**TO:** T10 Membership  
**FROM:** Paul A. Suhler, Quantum Corporation  
**DATE:** 13 June 2008  
**SUBJECT:** T10/07-469r5, ADT-2: Internet ADT (iADT)

**Figure 4 – Communication model**

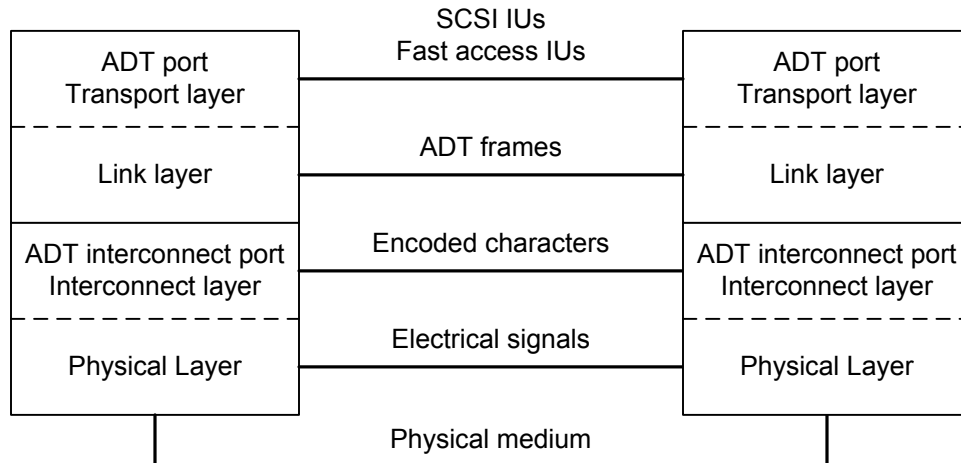
Figure 4 shows the communication between ADT ports and between ADT interconnect ports at the different layers of the protocol, from the physical layer to the transport layer.

**Figure 6 – ADT serial port example**

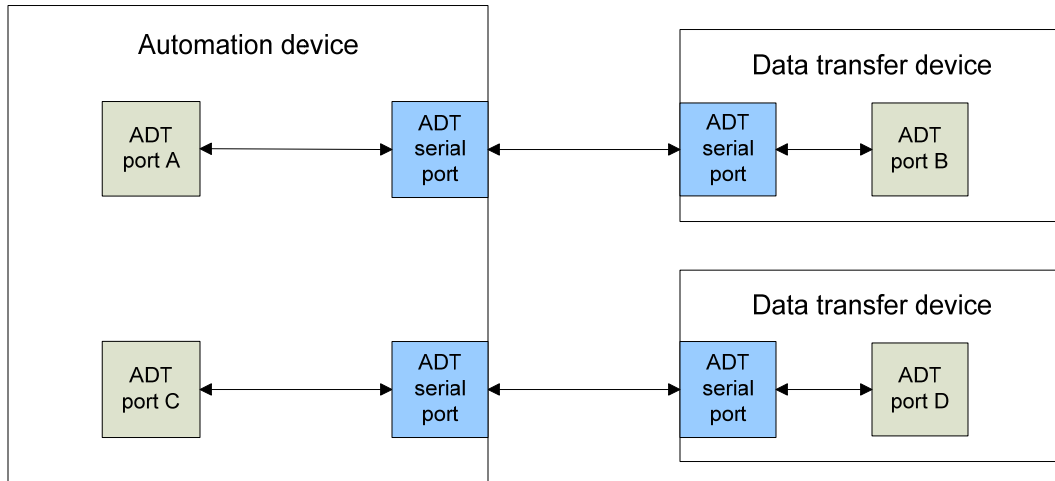
The term ADT serial port refers to an ADT interconnect port using the ADT serial bus (see 5.3) and the ADT serial interconnect layer (see clause 6). A single ADT port may use an ADT serial port for connection with another device. Figure 6 shows connections corresponding to Figure 3. ADT port A is connected with ADT port B, and ADT port C is connected with ADT port D.

**Figure 7 – ADT TCP port example**

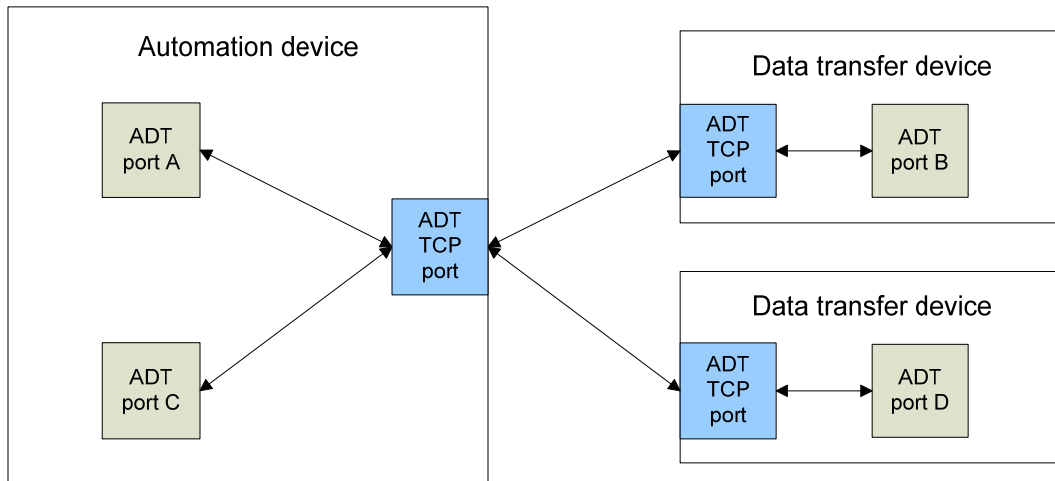
The term ADT TCP port refers to an interconnect port using the ADT Ethernet bus (see clause 5.3) and the ADT TCP interconnect layer (see clause 6). Multiple ADT ports in one device may share a single ADT TCP port for connection to other devices. Figure 7 shows two pairs of ADT ports connected by ADT TCP ports, corresponding to the connections shown in Figure 3. ADT port A is connected to ADT port B, and ADT port C is connected to ADT port D.
